MANUAL IDENTIFICATION

Model Number: 8690B
 Date Printed: May 1972
 Part Number: 08690-90018

This supplement contains important information for correcting manual errors and for adapting the manual to instruments containing improvements made after the printing of the manual.

P/O Figure 7-3. Frequency Control Section Reciprocal Amplifier

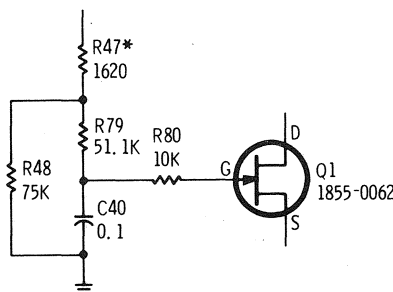
Change the circuitry of A3Q1 as shown in the attached drawing:

Component Identification, Assembly A9

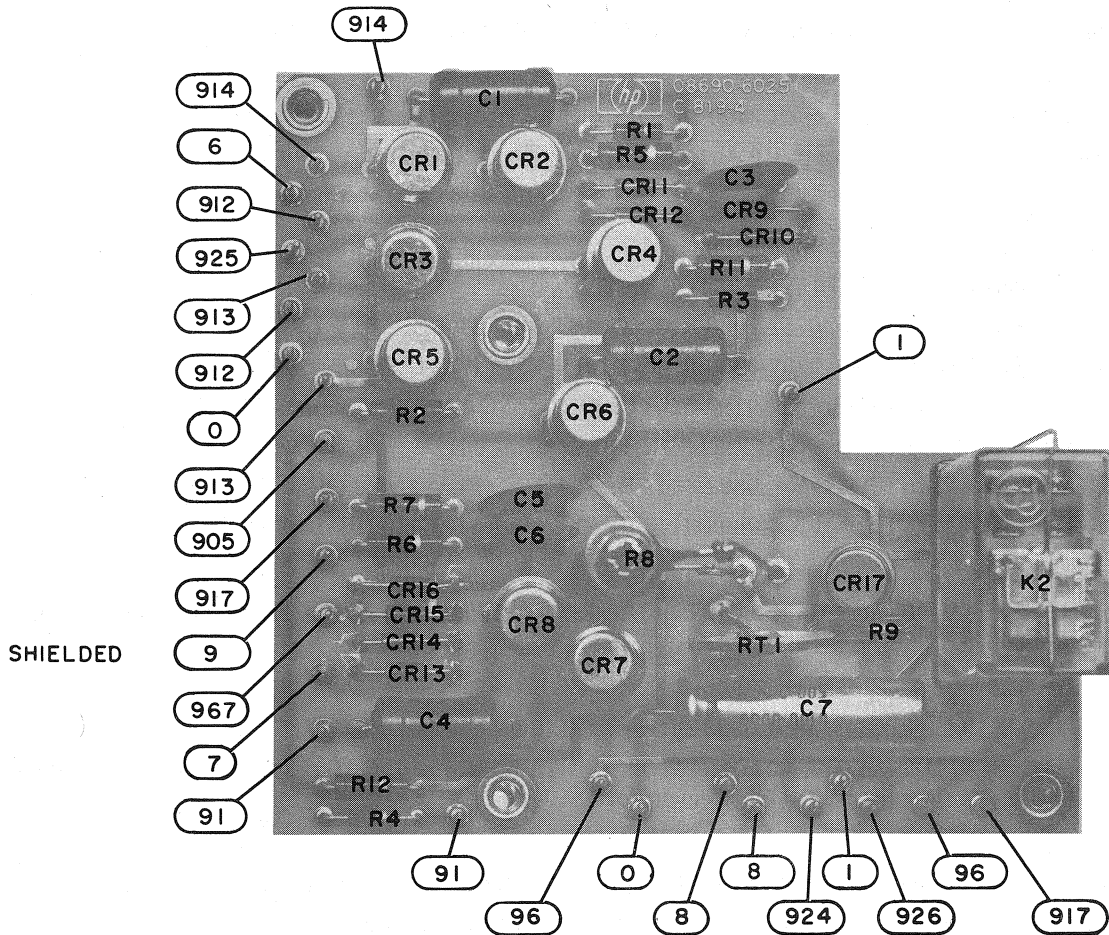
Page 7-14 and 7-16, Component Identification, Assembly A9:

Substitute the attached A9 Component Identification board for that shown in the 8690B Manual.

Figure 1. Component Identification, Assembly A8 (Part of Change 1)

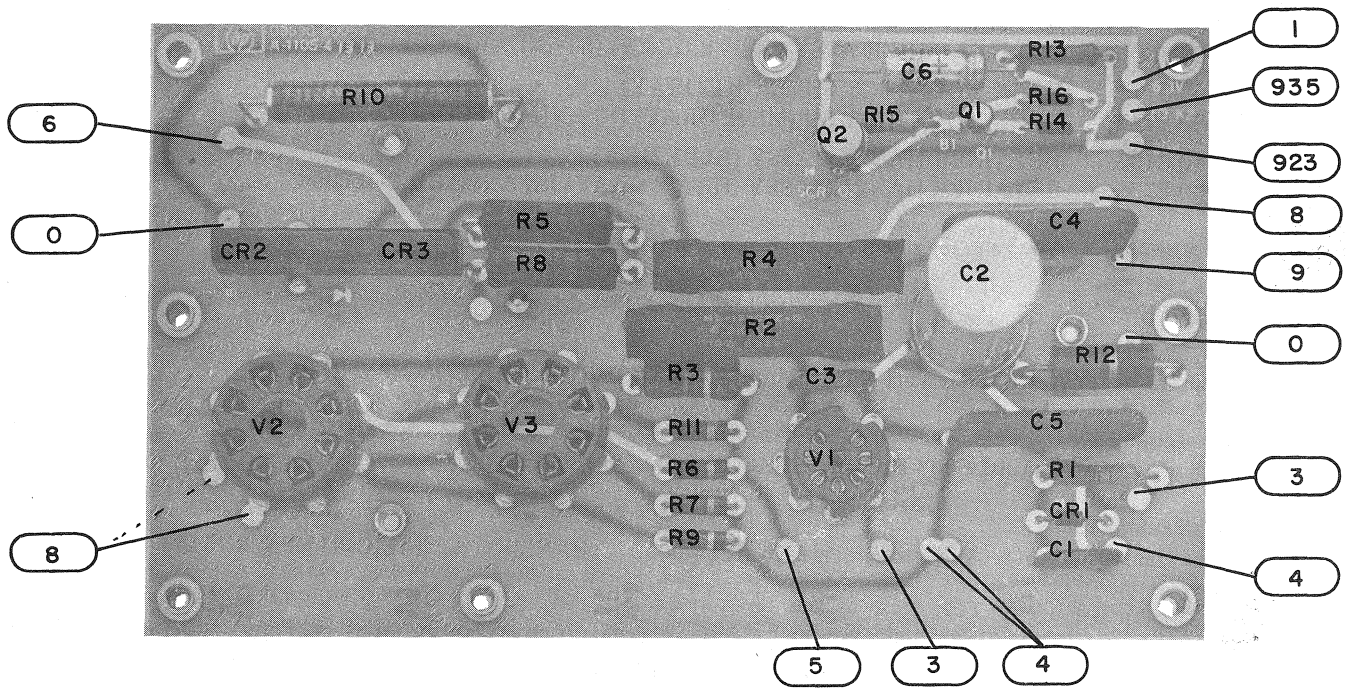
Substitute the attached A8 Assy, Component Identification board photo (Figure 1) for the photo shown in the 8690B Manual.

Figure 2. Component Identification, Assembly A14 (Part of Change 2)

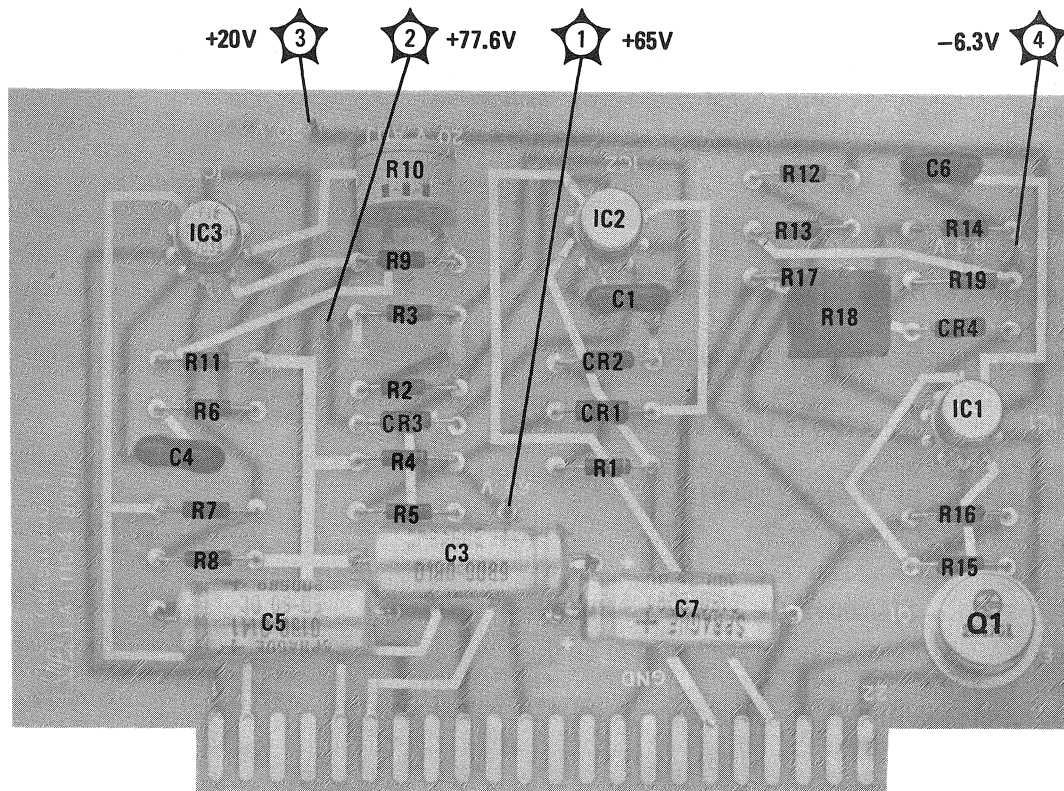
Page 7-14/7-15, Component Identification photo and Figure 7-8:

Substitute the attached A14 Assy board photo and schematic (Figures 2 and 3) for those shown in the 8690B Manual.

Figure 4. Component Identification, Assembly A4 (Part of Change 5)

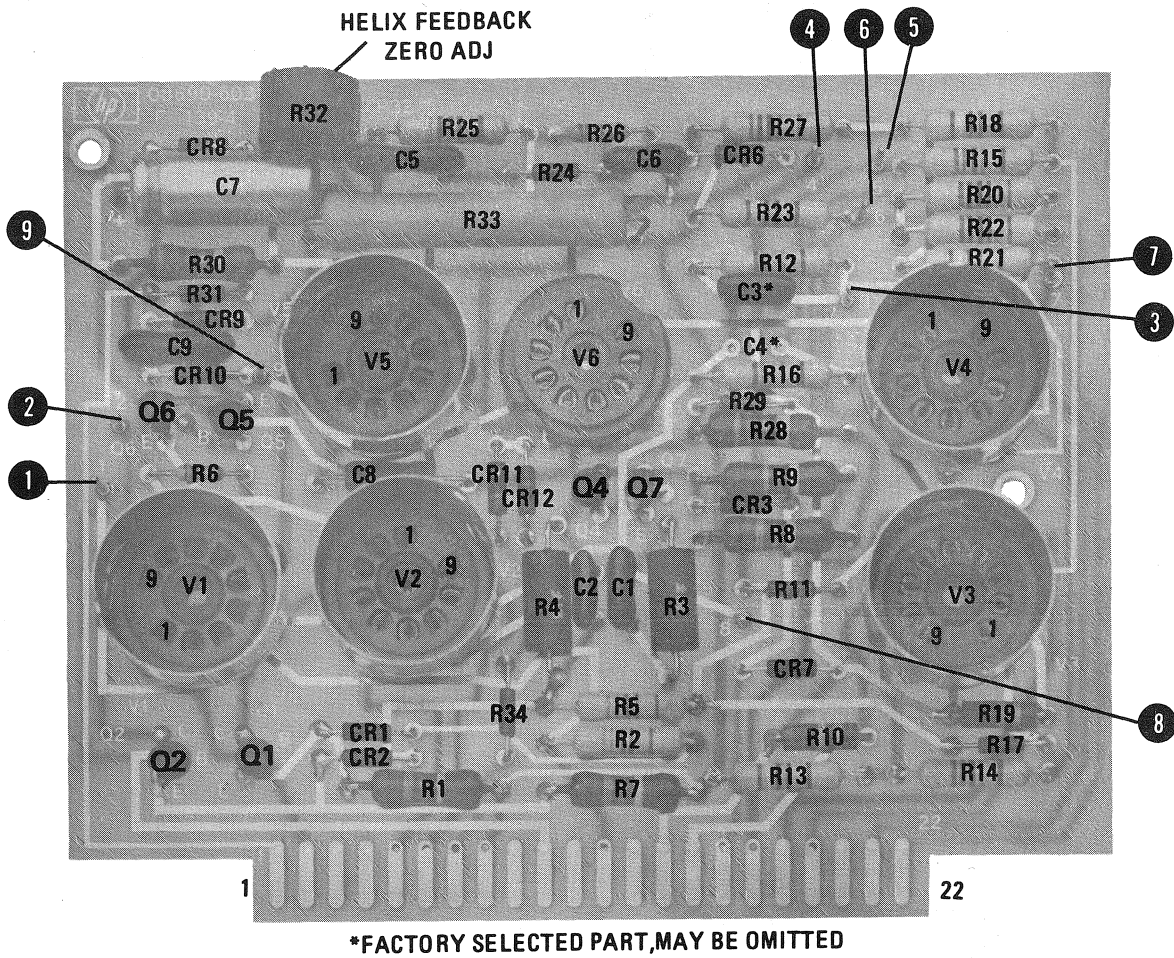
Add diode A4CR12 in series with zener diode A4CR11. Connect cathode of A4CR12 to ground, and anode to A4CR11.

Figure 5. Component Identification, Assembly A3 (Part of Change 1)

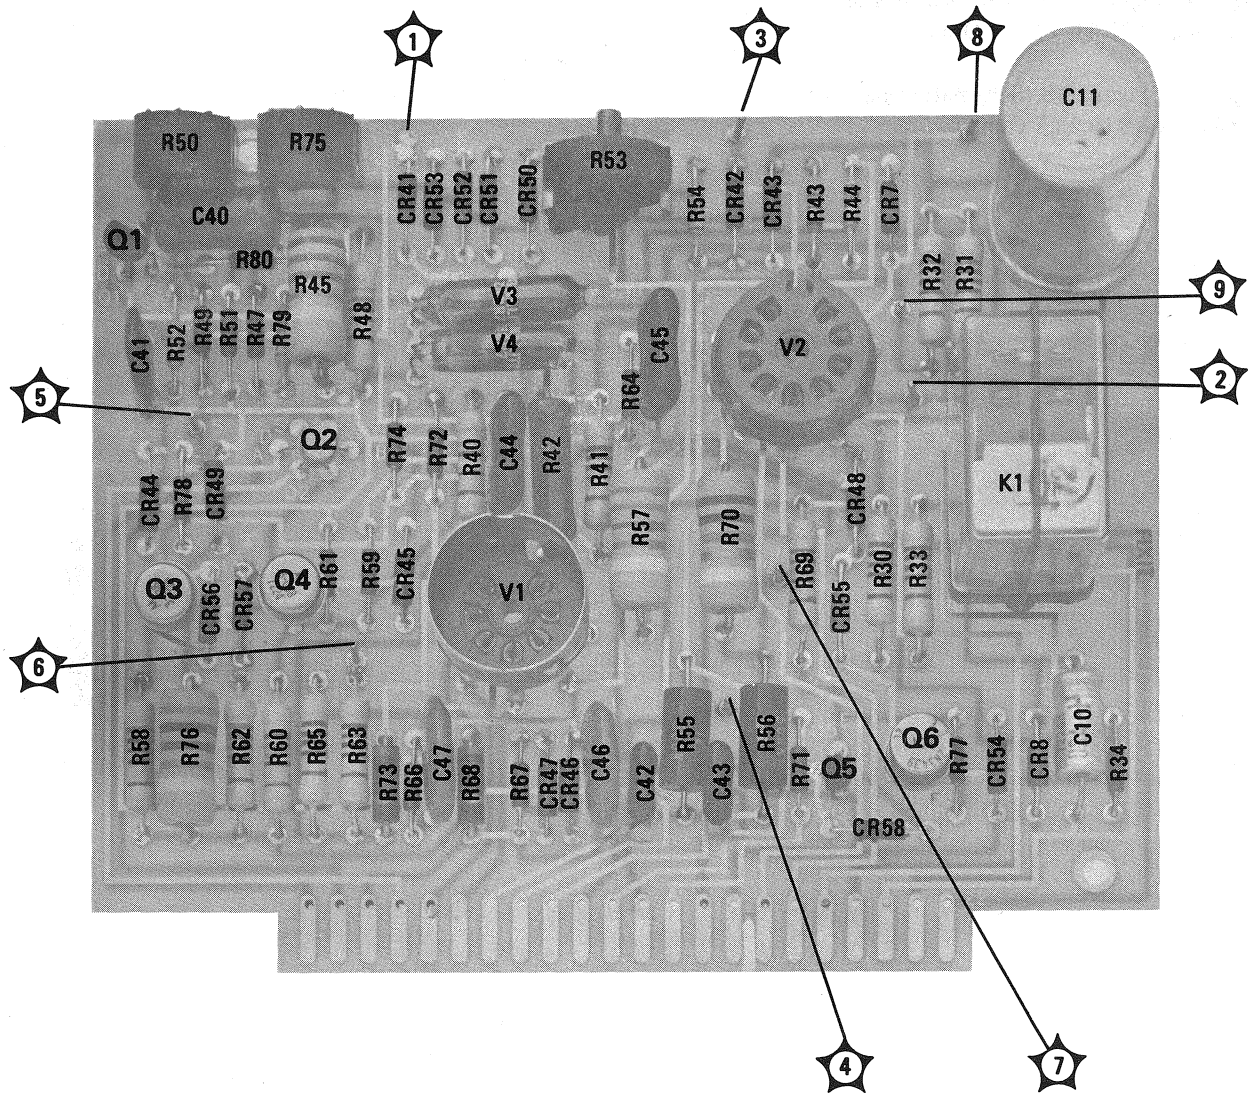
Substitute the attached Component Identification Assembly A3 board photo (Figure 5) for the photo shown in the manual.
